No.ECR/S&T-HQ/DRG/POLICY/

Sub : Hazard of point position not corresponding to the detection received in interlocking.

Ref : RDSO letter No. RDSO-SIG0EI(CKT)/1/2020, Dt. 19-7-2023.

SHT-1

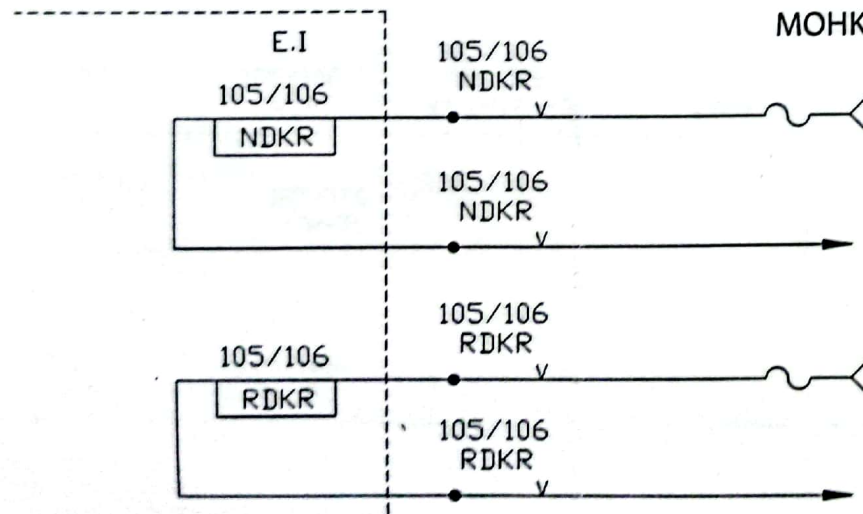
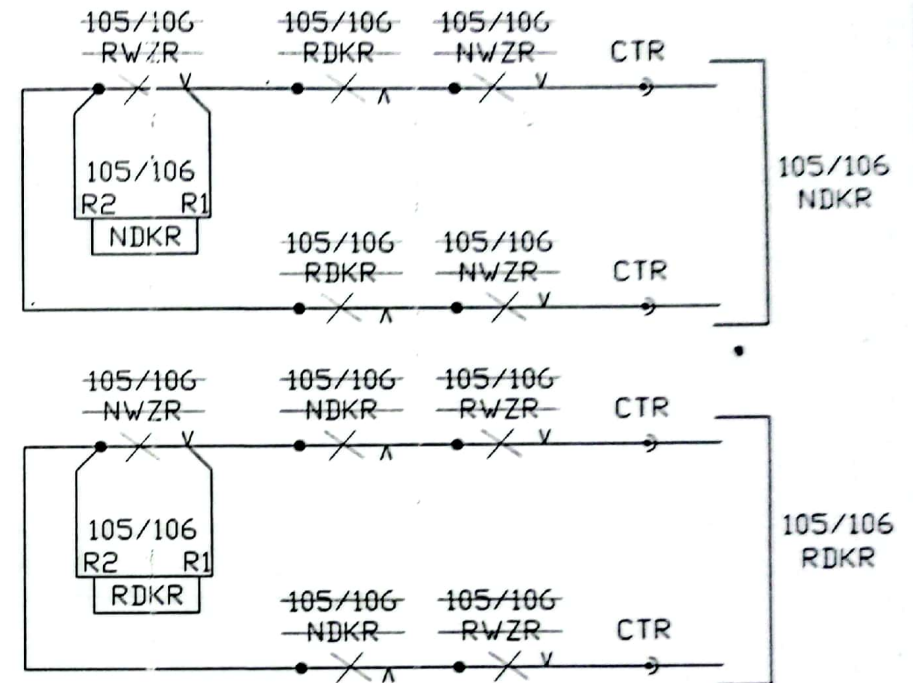
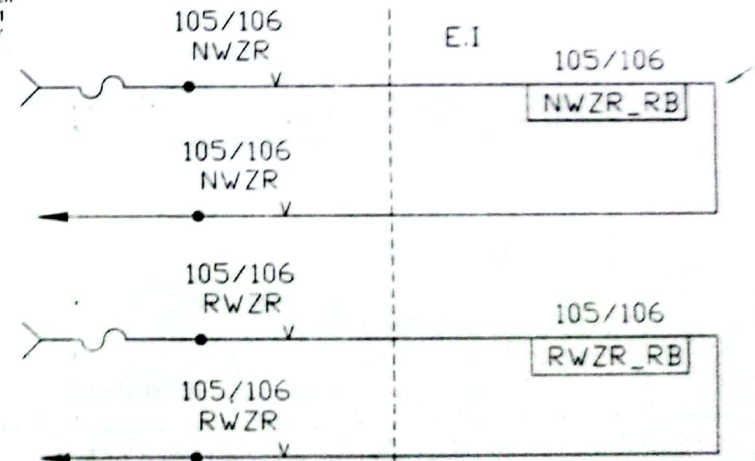
- a) Please refer enclosed SHT-1, It is proposed to remove all the contacts in NDKR & RDKR circuits including across the coils. NWZR(front) & RWZR(front) readback should be wired as input to EI to prove correspondence and converse back in concerned NWKR/RWKR logic. Converse back contacts of NDKR/RDKR should be proved in EI logic which will disable NWKR/RWKR in case any false feed picking up converse RDKR/NDKR(SHT-3). NDKR/RDKR coil shorting contacts of NWZR/RWZR also should be removed to get checked availability of any false feed on converse detection circuit. Due to these changes converse back contacts of RDKR/NDKR will have to be removed from NWCZR/RWCZR circuits(SHT-4).

SHT-2

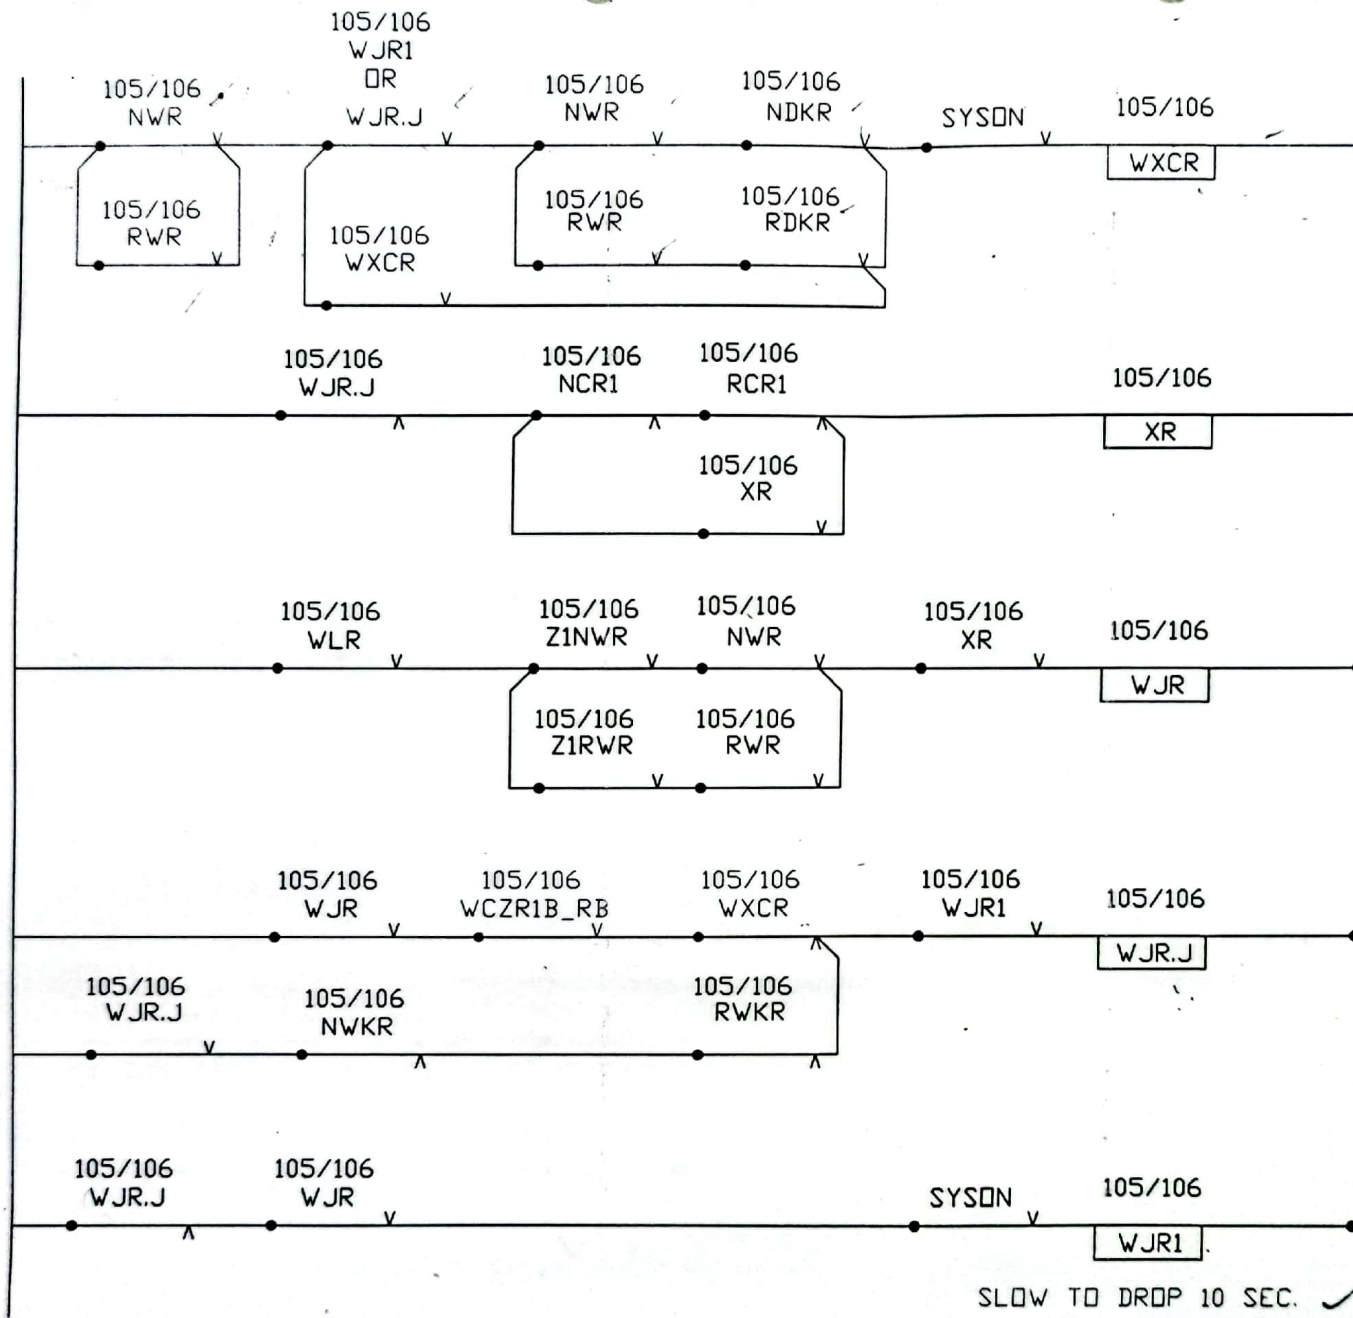
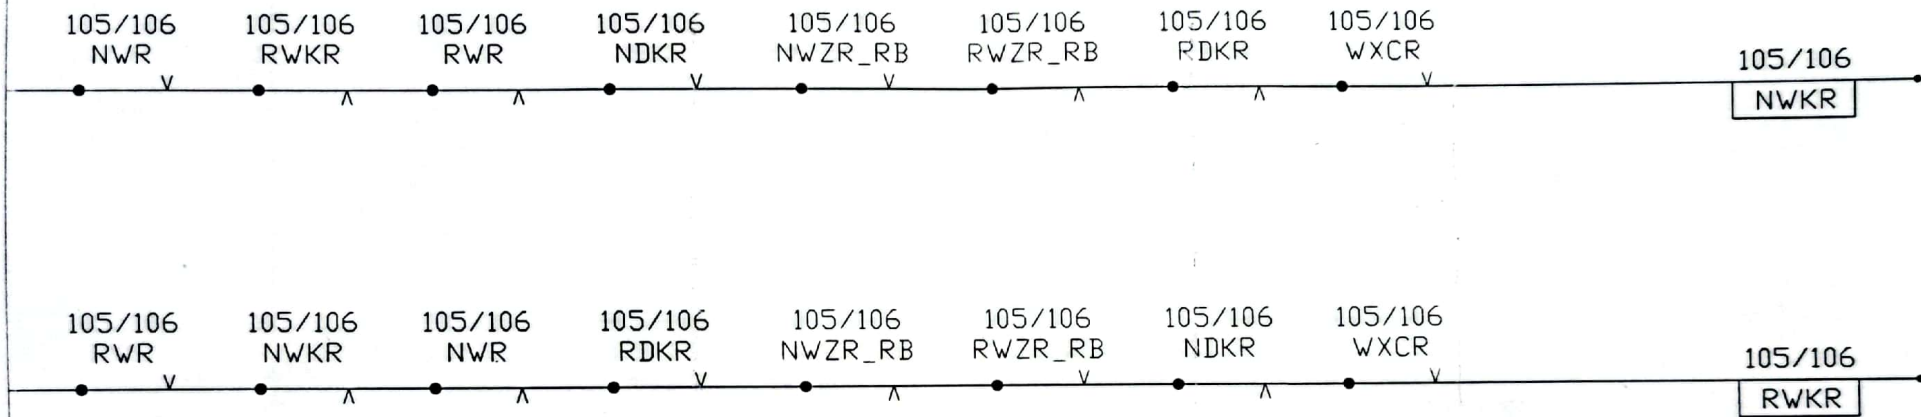
- b) WCZR1(back) readback should be wired as input to EI, which should be proved in WJR.J pick up circuit to prove that WCZR1 picked up during earlier operation has gone down(SHT-2 & 3). This is very essential because if this relay remains permanently pick due to any reason(contact welding, false wiring, etc.), it will not get detected as NWCZR/RWCZR will operate points as per requirement. This situation is similar to existing NDKR/RDKR circuit which does not detect availability of permanent feed simultaneously at the CT Rack terminals of both NDKR/RDKR. WCZR1 remaining permanently pick will make N110(CW) permanently available at point motor(SHT-1) and two adverse earth faults will operate the motor bypassing entire interlocking. Point circuit needs to be made flawless.
